# Work Order ID 66728

Item Name: 205 Skidtube bent detail

DRAWING NO. D2580	TITLE 205 SKIDTUBE ASSEMBLY	REV. D	DART AEROSPACE LTD ENGINEERING ORDER		D.E.O. NO. D2580-D-1	SHEET NO. SHEET 1 OF 1	SCALE NTS
DRAWN <i>UP</i>	CHECKED <i>L</i>	MFG. APPR. <i>R</i>	APPROVED <i>MP</i>		DE APPR. <i>MP</i>		
DATE 10.09.22	DATE 10.11.04	DATE 10.11.04	DATE 10/11/04		DATE 10.11.04

CHANGE ALL WELDED CROSSBOLT SPACERS TO SWAGED SPACERS

SECTION D-D & SECTION H-H ARE AMENDED AS FOLLOWS:

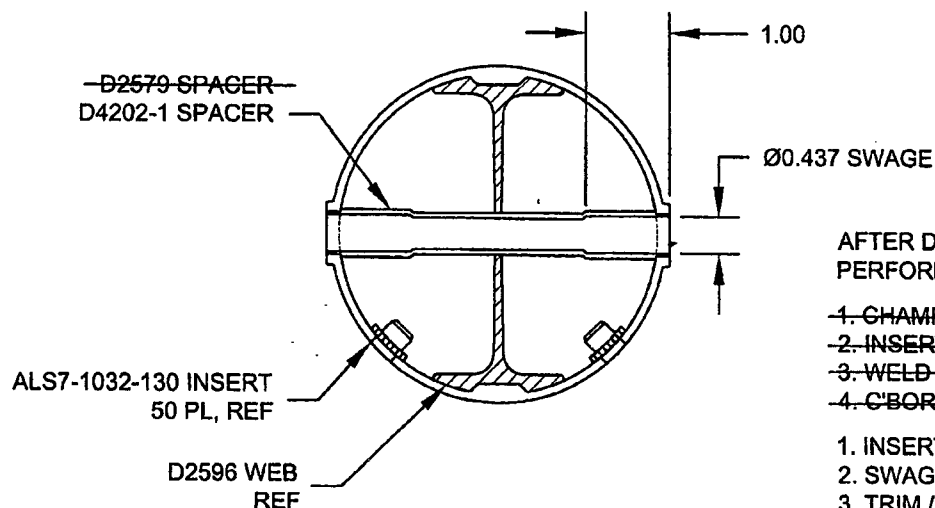
**WAS**

QTY	QTY	PART NUMBER	DESCRIPTION
-041	-045		
20	24	D2579	CROSS BOLT SPACER

AFTER DRILLING AND BENDING ASSEMBLY  
PERFORM THE FOLLOWING FOR Ø0.508 HOLES ONLY:

1. CHAMFER HOLE 0.050 X 45°
2. INSERT D2579 SPACER (20 PLACES)
3. WELD INTO PLACE AND GRIND FLUSH
4. C-BORE D2579 SPACER TO Ø0.437 X 1.00 DEEP
1. INSERT D4202-1 SPACER, 20 PL (-041) OR 24 PL (-045)
2. SWAGE TO Ø0.437 X 1.00 DEEP PER QSI 002
3. TRIM / GRIND FLUSH PER QSI 002

**IS**

20	24	D4202-1	SPACER
----	----	---------	--------
